## **Cowal Gold Mine – Addendum to the Erosion and Sediment Control Management Plan**

COWAL GOLD MINE  
ADDENDUM TO THE EROSION AND SEDIMENT CONTROL  
MANAGEMENT PLAN

FEBRUARY 2015  
Project No. HAL-02-07  
Document No. 00653984

**ADDENDUM**  
**Erosion and Sediment Control Management Plan**

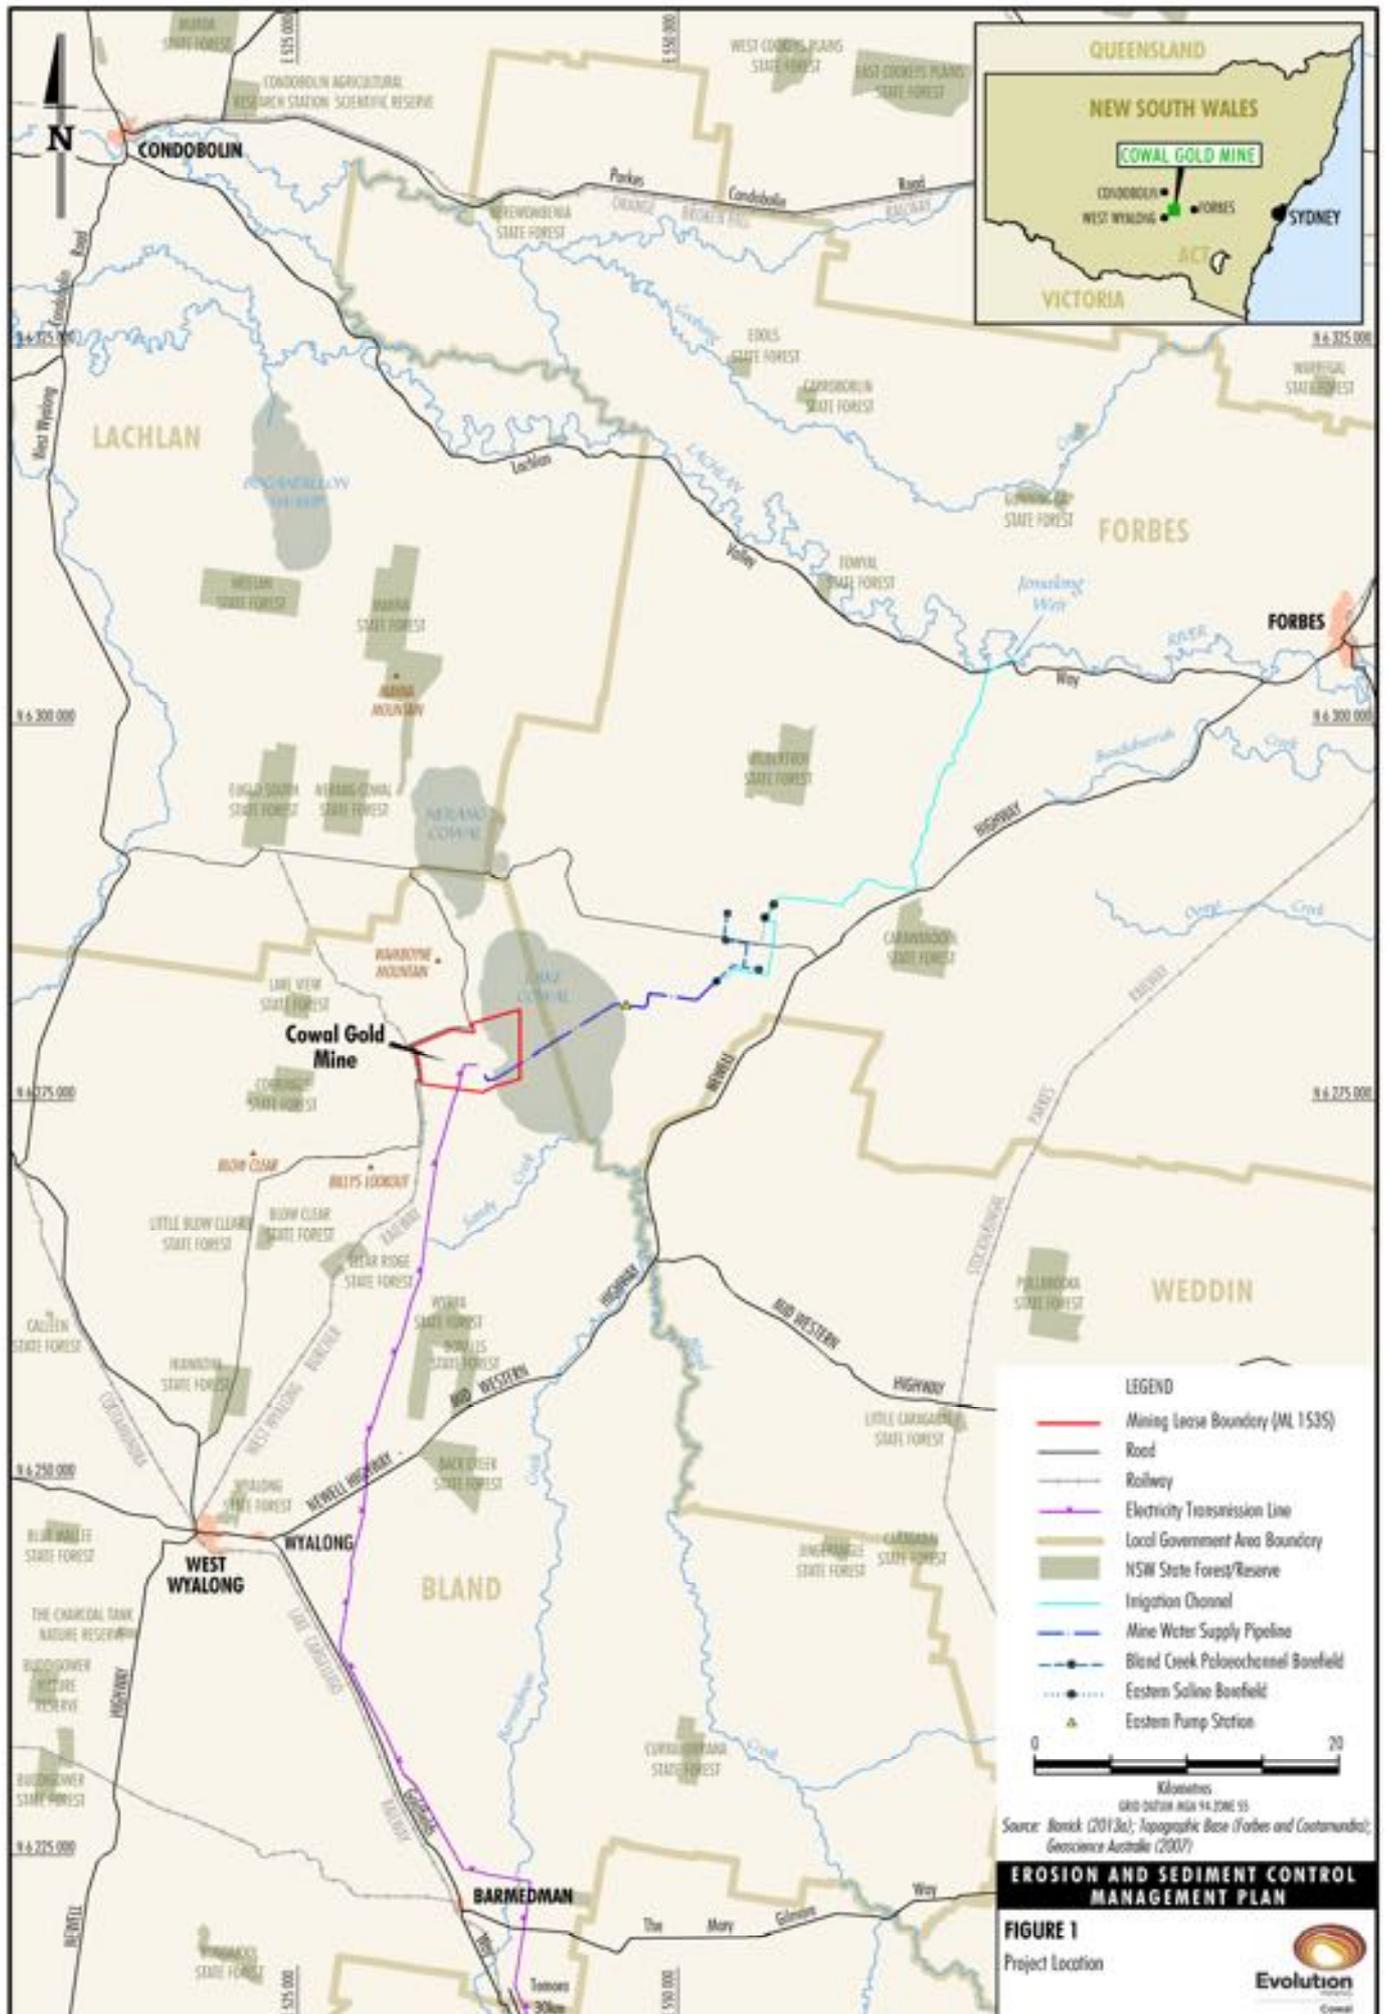
5. Replace Figure 4 with attached Figure 4.
6. Insert the following text after the first paragraph of Section 3.4.1(d):

Additional soil stockpiles will be constructed west of the northern waste rock emplacement within the Internal Catchment Drainage System and in the north of Mining Lease (ML) 1535 (Figure 4). The erosion and sediment control systems for the stockpiles within the Internal Catchment Drainage System will be as described in Section 3.3.1.

For the stockpile in the north of ML 1535, prior to placement of the topsoil, upslope runoff would be directed around the stockpile area via a system of diversions/drains/bunds. Runoff from the soil stockpile area itself would be directed to a sediment basin constructed at the eastern boundary of the stockpile area (Figure 4).

The upslope stockpile diversions and sediment basin would be constructed, operated and maintained in accordance with Landcom (2004) *Managing Urban Stormwater – Soils and Construction Volume 1* and Department of Environment and Climate Change (DECC) (2008) *Managing Urban Stormwater – Soils and Construction Volume 2E Mines and Quarries* (Gilbert and Associates Pty Ltd, 2013).
